Executive Director's Recommendation

Commission Meeting: October 2, 2014

PROJECT Constitution Gardens Rehabilitation The National Mall Washington, DC	NCPC FILE NUMBER 7421
SUBMITTED BY United States Department of the Interior National Park Service	NCPC MAP FILE NUMBER 1.43(70.00)44007
REVIEW AUTHORITY Approval per 40 U.S.C. § 8722(b)(1) and (d)	APPLICANT'S REQUEST Approval of comments on concept design
	PROPOSED ACTION Approve comments as requested
	ACTION ITEM TYPE Staff Presentation

Figure 5: Proposed 18 inch wall and grade modifications

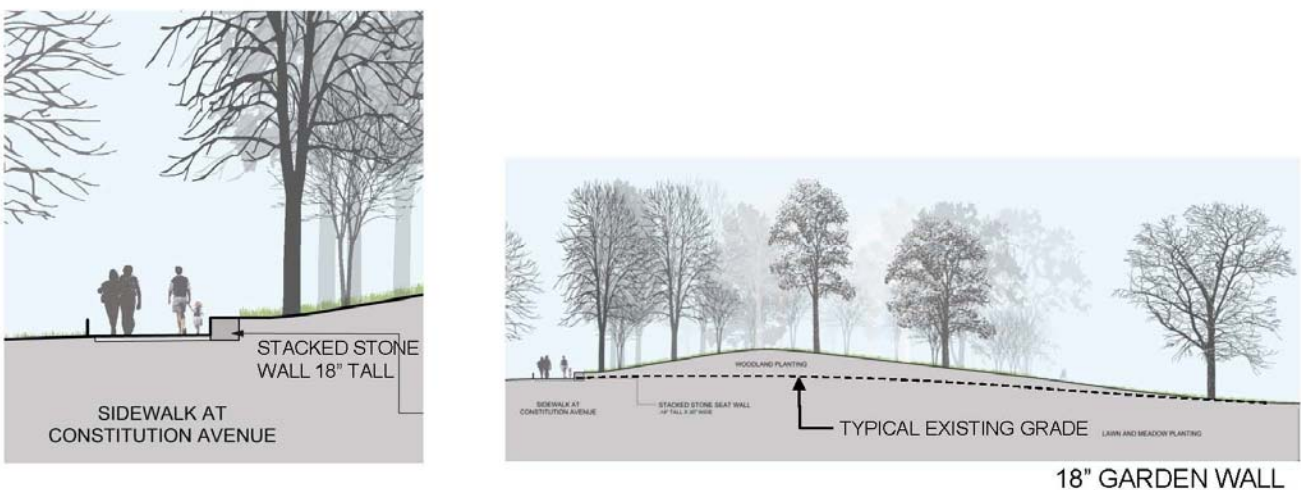
The strength of the Hybrid Alternative is that it maximizes sustainability principles while also providing improved visitor services that will activate the garden. With the Hybrid Alternative a low wall (18 inches) would be constructed along Constitution Avenue and 17th Street to define the edge of the space and establish a threshold for entering and exiting the park. At 18 inches in height, the wall will likely not be a visual obstruction into the setting of Constitution Gardens. Combined

with the proposed changes to the topography to accommodate the upland woodland area, views into and from Constitution Gardens may be impacted due to the height of the landforms. The topography will be amplified and raised four to eight feet from existing conditions, using fill from the lake excavation. The average height of the hills relative to Constitution Avenue will be six and a half feet. The change in the topography has the potential to alter and block views towards Constitution Gardens from Constitution Avenue as well as from within the garden out towards the street and towards the buildings along Constitution Avenue. The buildings along Constitution including the Federal Reserve Board, American Pharmacists Association, and the National Academy of Sciences help to establish the setting of the park and these views should be considered as the project moves forward. Therefore, staff is recommending that the Commission **request additional simulations of the surrounding views and vistas, both to and from the park in order to better understand the implications of proposed changes to topography and construction of walls along Constitution and 17th Street and the impacts of the pavilion design and lighting on views to and from the World War II Memorial and from other important vantage points along the National Mall.**

Figure 6: Plan for Lockkeeper's House and new entry plaza

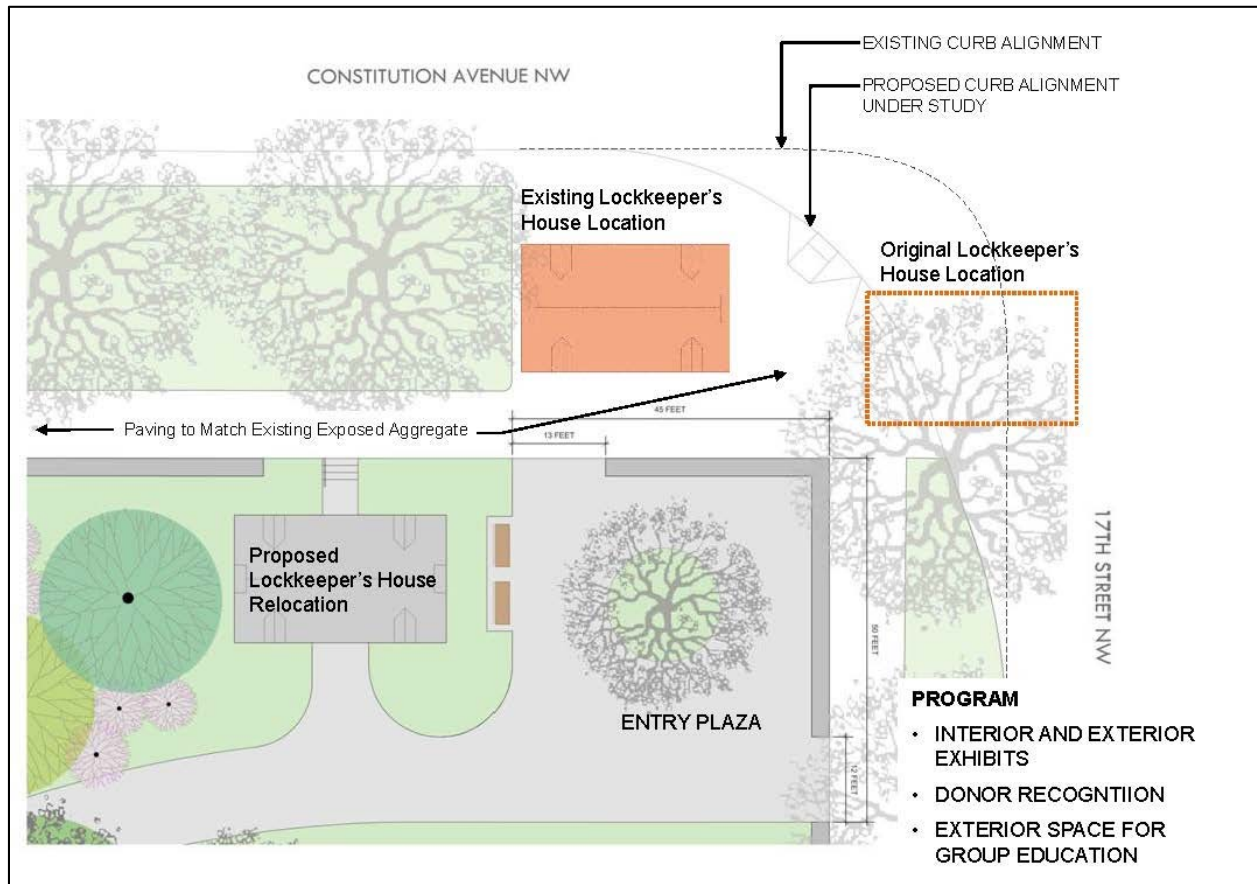
In addition, under the hybrid alternative, the Lockkeeper's House would be relocated slightly to the southwest of its current location. As the oldest structure in East and West Potomac Park and the only structure related to the Chesapeake & Ohio and Washington City Canals, shifting the building slightly to the southwest so that it can maintain its historic spatial relationship is a more appropriate preservation approach than moving the structure almost 500 feet to the west (proposed under Alternative 2). The Lockkeeper's House is proposed to be used for small exhibits as well as donor recognition. Additional consultation under Section 106 of the National Historic Preservation Act is required to understand the modifications proposed for the interior of the space and the preservation implications.

Figure 14: Proposed loading access from 17th Street

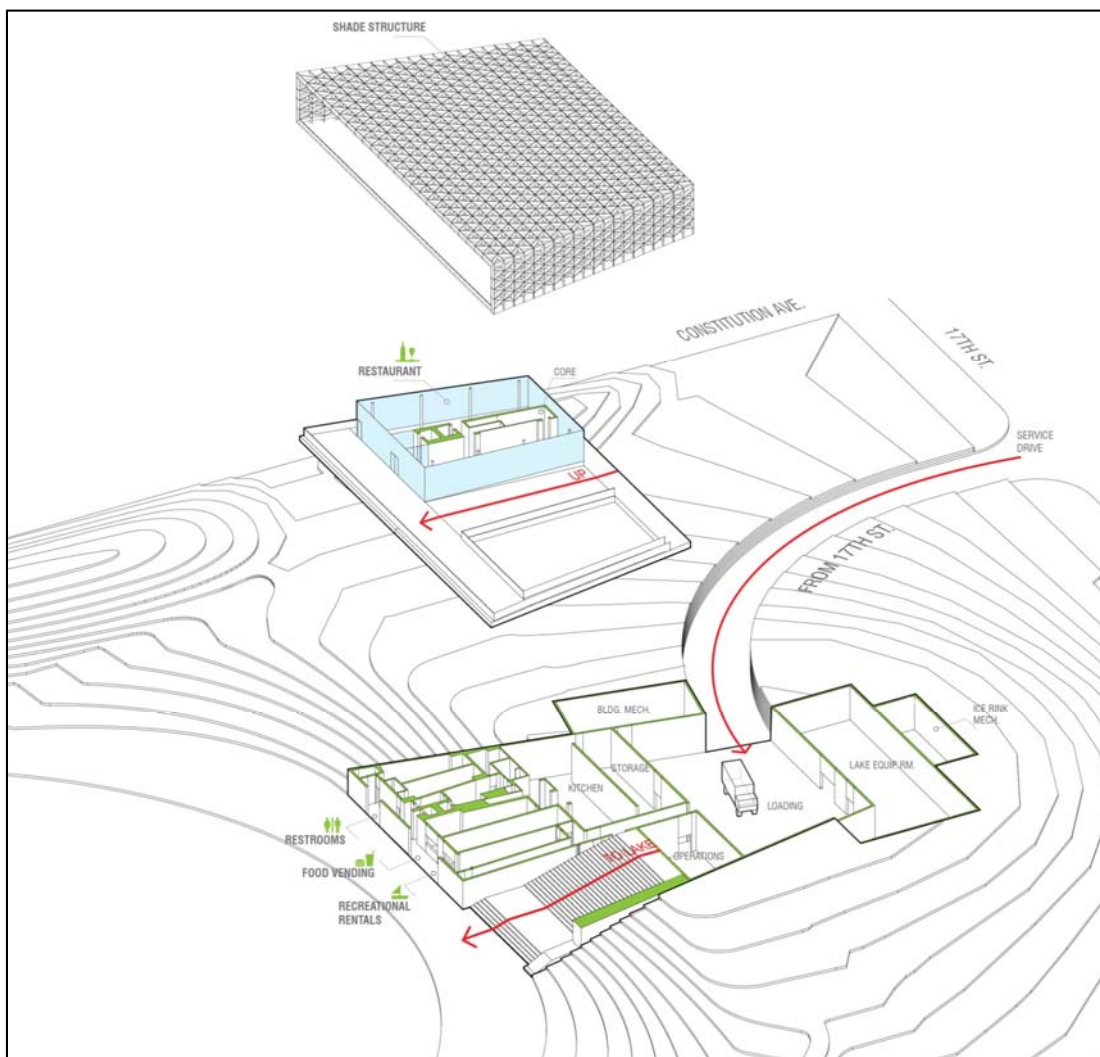
Access for service vehicles to the pavilion is proposed off of 17th Street to avoid conflicts with pedestrians walking in the garden as well as tour-bus drop off and pick-up points. The design and location of this service drive requires additional refinement and will require coordination and consultation with the District of Columbia Department of Transportation (DDOT). The size of the driveway should be kept to the minimum required. Coordination with DDOT will also be required

for the proposed modifications to the curb radius at Constitution Avenue and 17th Street. While staff recognizes the need to address congestion of the intersection and accommodate tour buses, pedestrian safety should be prioritized over vehicles. Therefore, staff is recommending that the Commission **recommend the National Park Service coordinate with the District of Columbia Department of Transportation on the design and location of the proposed pavilion service entrance on 17th Street and the modifications to the curb radius at Constitution Avenue and 17th Street.**

Recommends that the National Park Service coordinate with the District of Columbia Department of Transportation on the design and location of the proposed pavilion service entrance on 17th Street and the modifications to the curb radius at Constitution Avenue and 17th Street.
